World Forum for Harmonization of Vehicle Regulations

Proposal for the 01 series of amendments to Regulation No. 121 (Identification of controls, tell-tales and indicators)

Submitted by the Working Party on General Safety Provisions *

Table 1, amend to read (including the insertion of new footnote 21/):

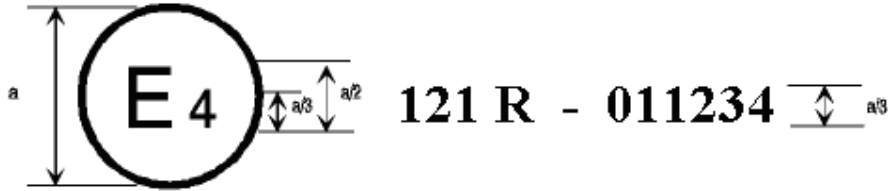
No.	Column 1	Column 2	Column 3	Column 4	Column 5
	ITEM	SYMBOL 2/	FUNCTION	ILLUMINATION	COLOUR
...
43.	Electronic stability control	 or ESC <u>17/</u>	Tell-tale	Yes	Yellow
44.	Electronic stability control system "OFF"	 or ESC OFF <u>17/ 21/</u>	Control	Yes	
			Tell-tale	Yes	Yellow

21/ The supplementary letters "OFF" may be positioned on or adjacent to the outline of the symbol of item No. 43. The font of the letters "OFF" or "ESC OFF" is not intended to be restrictive (Note: the letters "OFF" and "ESC OFF" shall be kept in English and shall not be translated)."

Model B

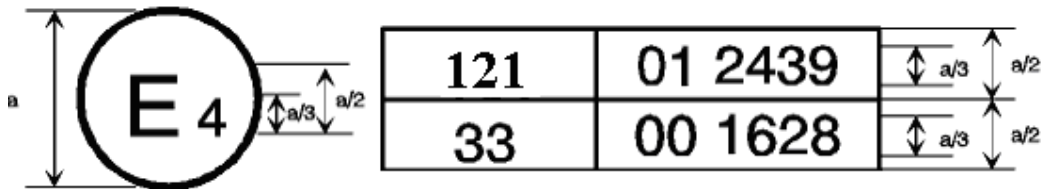
Annex 2, approval mark models A and B, amend to read (existing footnote ¹ remains unchanged):

The above approval mark affixed to a vehicle shows that the vehicle type concerned has been approved in the Netherlands (E4) pursuant to Regulation No. 121 and Regulation No. 33¹. The approval number indicates that, at the dates when the respective approvals were granted in accordance with Regulation No. 121 as amended by the 01 series of amendments and with Regulation No. 33 which was still in its original form."
